Product Change Notification: MFOL-31SHMS864

CCB 8110 Final Notice: Qualification of MTAI as an additional assembly site for selected MIC4426, MIC4420, MIC4423, MIC4429, MIC4425, MIC4427, MIC4424, and MIC4428 device families available in 8L SOIC (3.90mm) package.

PCN Status: Final Notification

PCN Type: Manufacturing Change

Pre and Post Summary – Lead Frame Comparison

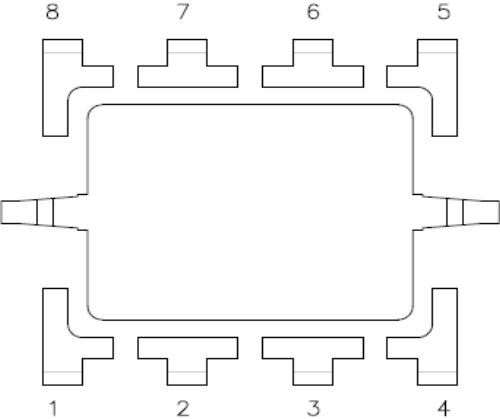
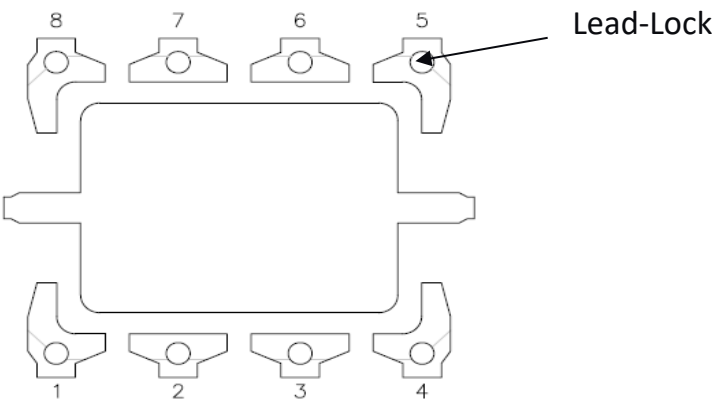
STAR and UNIS	MTAI												
 Note: Not to scale <table><tr><td>Lead-Frame Material</td><td>C194 / A194*</td></tr><tr><td>Lead-Frame DAP Surface Prep</td><td>NiPdAu</td></tr><tr><td>Lead-Frame Lead Lock</td><td>No</td></tr></table>	Lead-Frame Material	C194 / A194*	Lead-Frame DAP Surface Prep	NiPdAu	Lead-Frame Lead Lock	No	 Note: Not to scale <table><tr><td>Lead-Frame Material</td><td>CDA194*</td></tr><tr><td>Lead-Frame DAP Surface Prep</td><td>Bare Cu</td></tr><tr><td>Lead-Frame Lead Lock</td><td>Yes**</td></tr></table>	Lead-Frame Material	CDA194*	Lead-Frame DAP Surface Prep	Bare Cu	Lead-Frame Lead Lock	Yes**
Lead-Frame Material	C194 / A194*												
Lead-Frame DAP Surface Prep	NiPdAu												
Lead-Frame Lead Lock	No												
Lead-Frame Material	CDA194*												
Lead-Frame DAP Surface Prep	Bare Cu												
Lead-Frame Lead Lock	Yes**

Note:** Mold compound materials fills the leadlock hole, which provides improved protection against moisture penetration along the edge of the leads (pins) of the package.

Pre and Post Summary – Top Marking

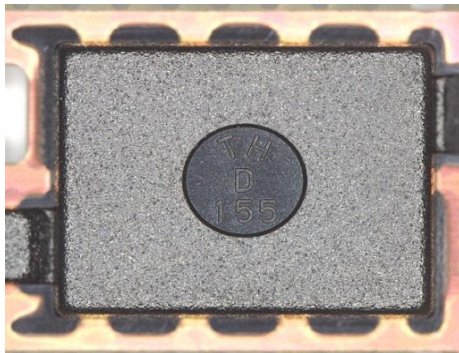
Top Marking : Line 1-3. No Back side marking. COO is TH engraved on the backside of the package

Marking			
Location	Line	Area	Marking data
FRONT	1	AssemblyMark	<MC>4423
FRONT	2	AssemblyMark	YM
FRONT	3	AssemblyMark	<O>WNNN
